Subject: Limerick Generating Station, Units 1 & 2
Information for Containment Systems Branch (CSB)
Primary Containment Negative Pressure Design Limit

Attached are draft changes to FSAR Section 6.2.1.1.4, Table 6.2-9 and Figures 6.2-19, 20 which are being made as a result of discussions at the referenced meeting.

TABLE 6.2-9

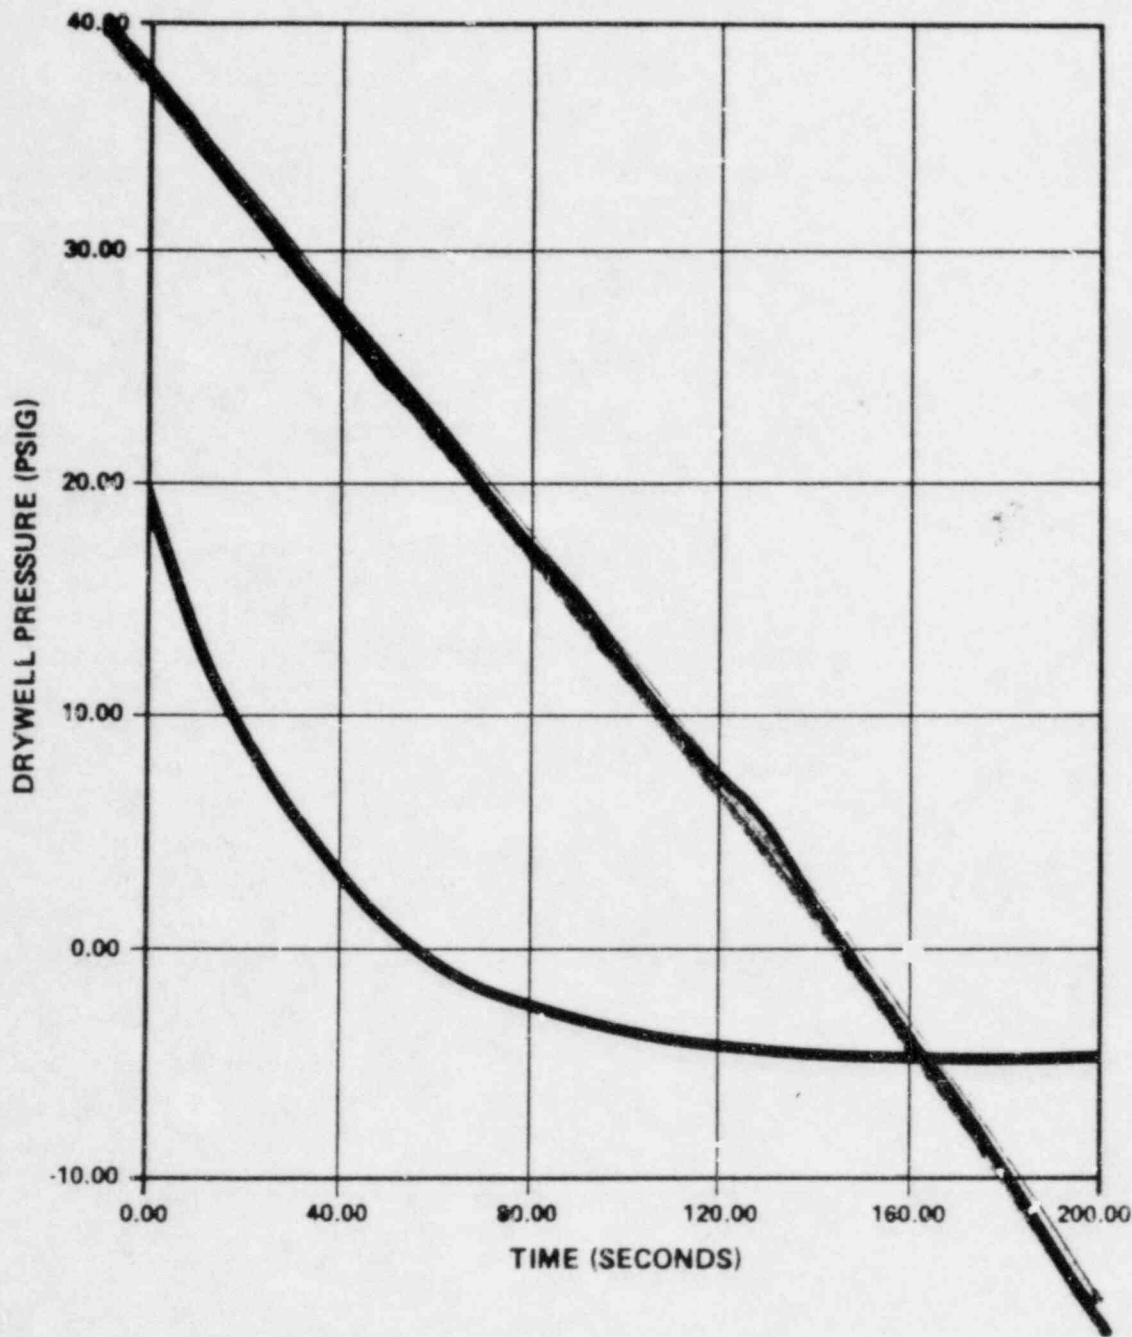
(3) ~~Free~~ water level

~~(4) Using this value, rather than the value 4974 ft² as listed in Table 6.2-1, has a negligible effect on results~~

~~(5) Using value is more conservative than using the value in Table 6.2-2~~

(4) Value given is for total flow path. Full open pressure differential across the vacuum breaker assembly only is 2.89 psid.

FIGURE 6.2-19

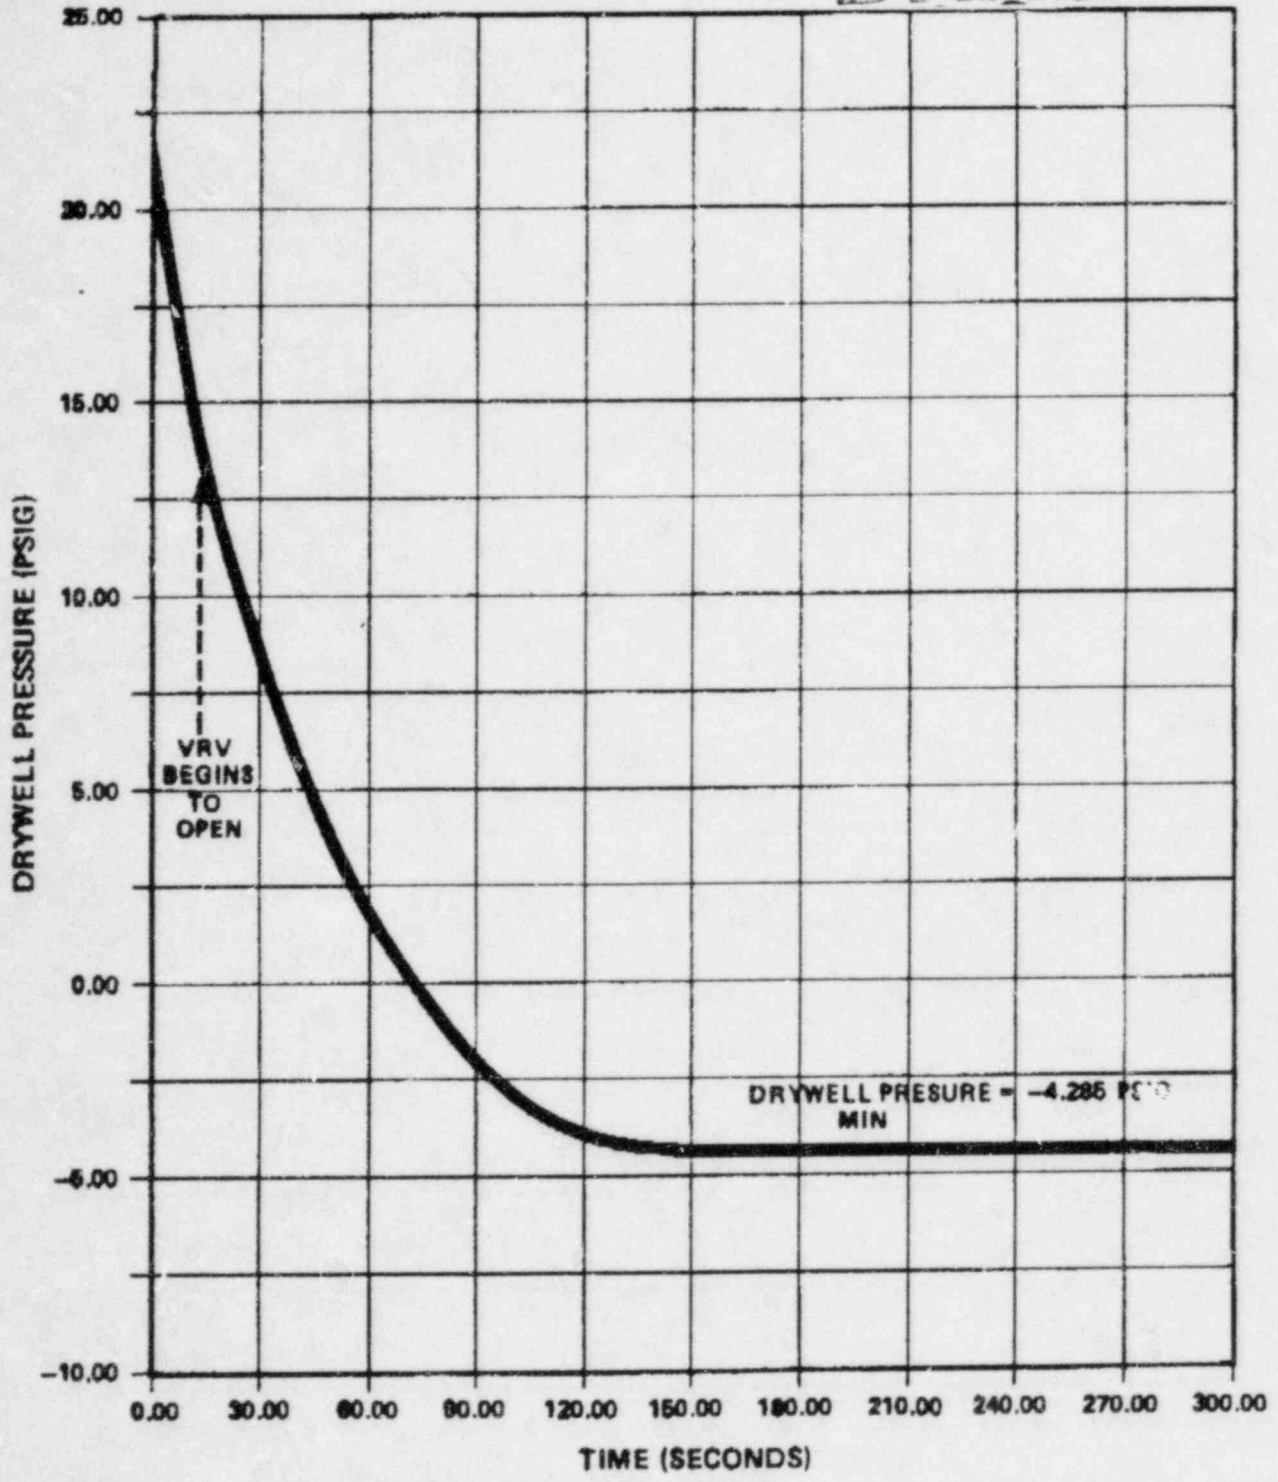
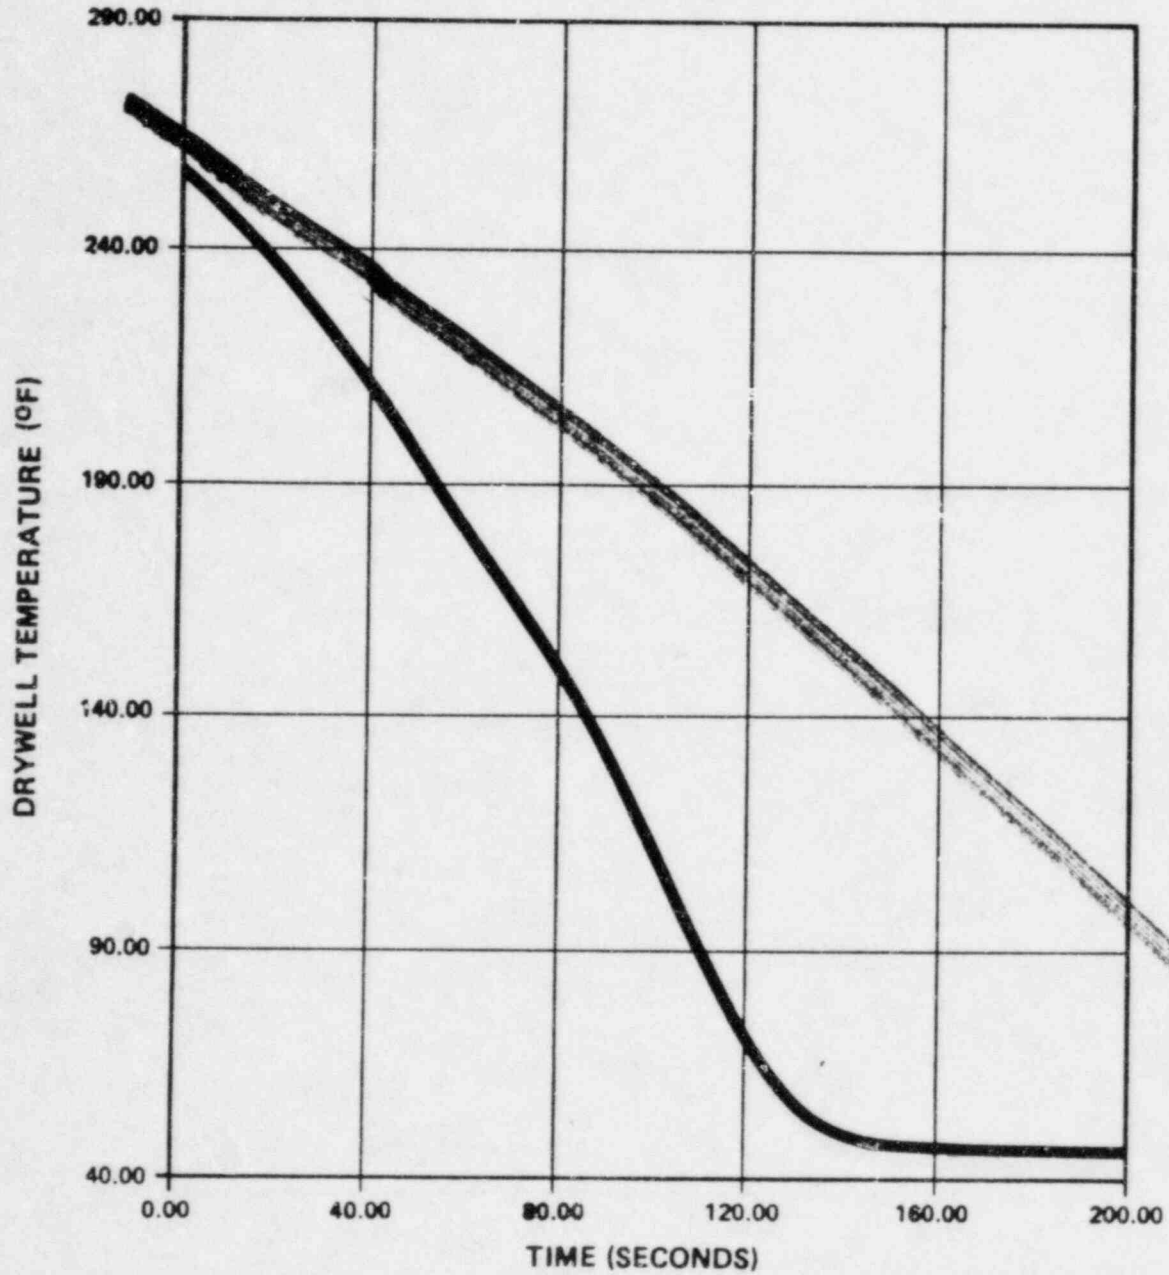
The results of this analysis are illustrated in Figures 6.2-19 and 6.2-20. Again, these results indicate a maximum negative drywell pressure of -4.3 psig.

DELETE & REPLACE WITH ATTACHED **DRAET**

FIGURE 6.2-19 REV. 38, 09/84

FIGURE 6.2-20

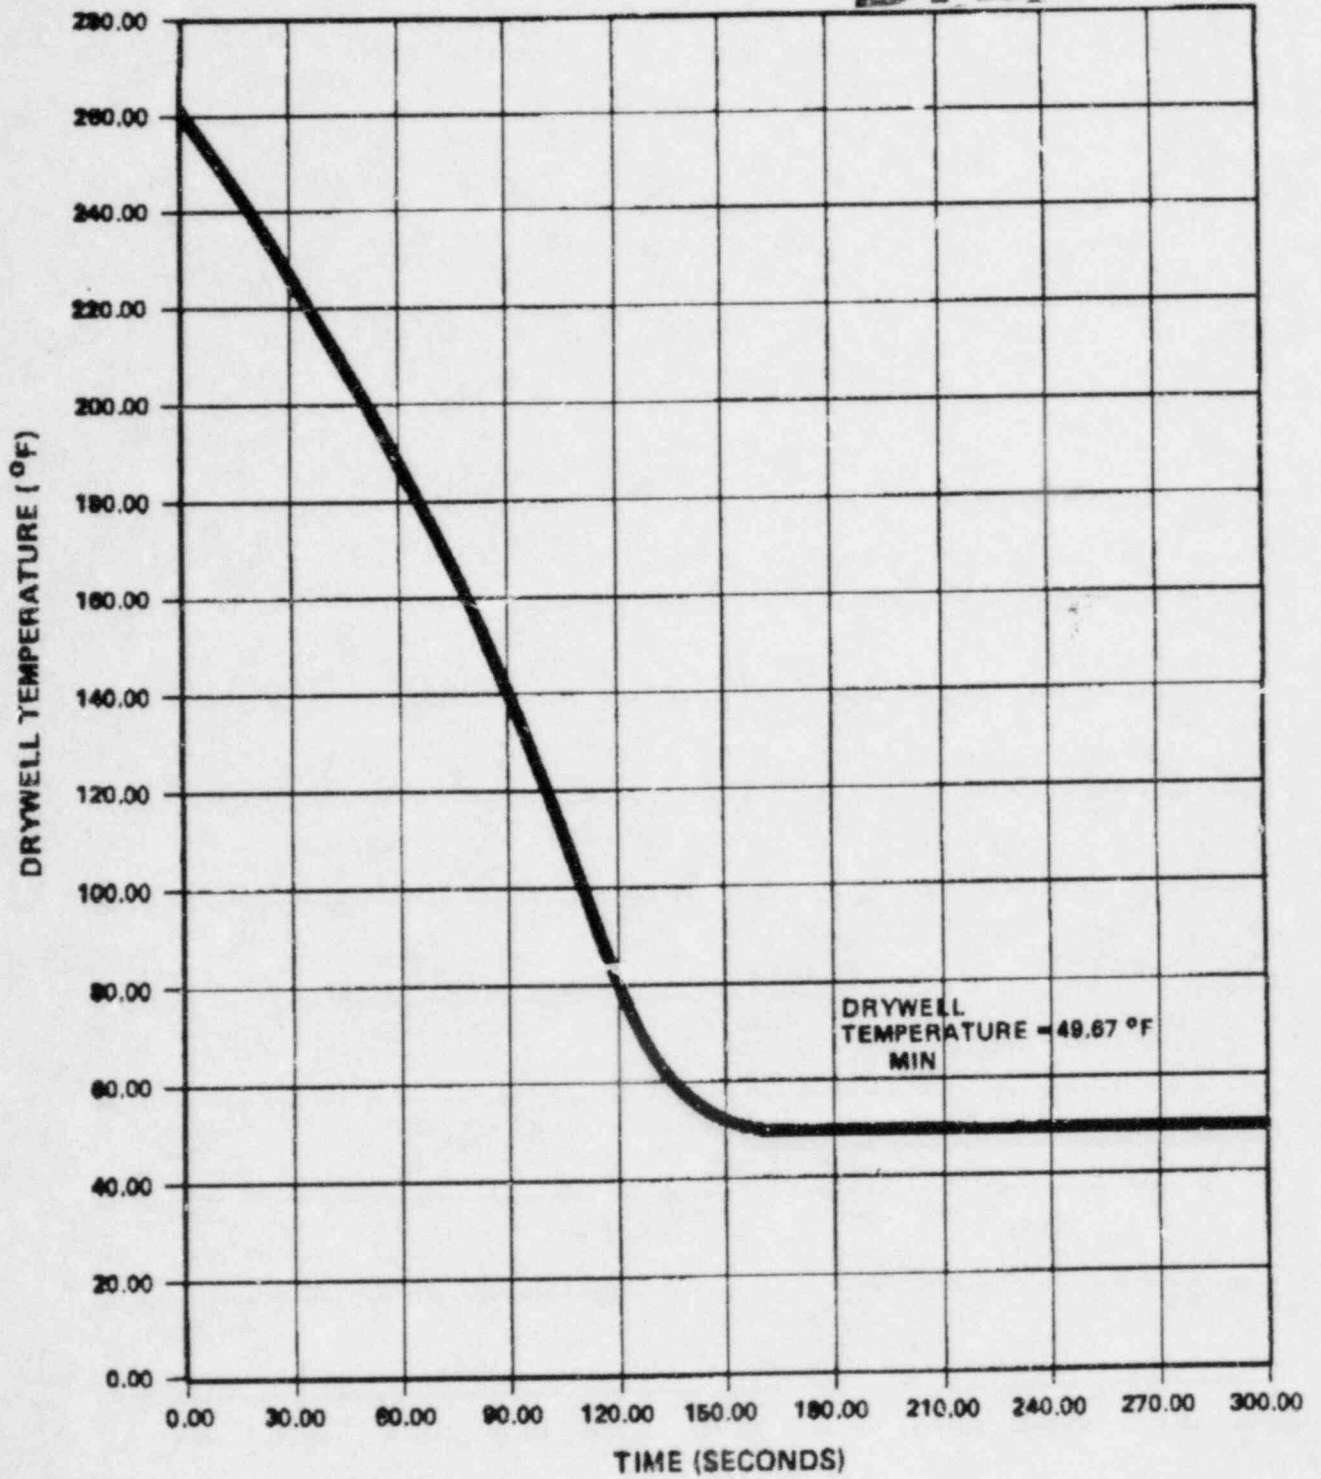
DELETE & REPLACE WITH ATTACHED

DRYWELL
TEMPERATURE - 49.67 °F
MIN

REV. 36. 09/84
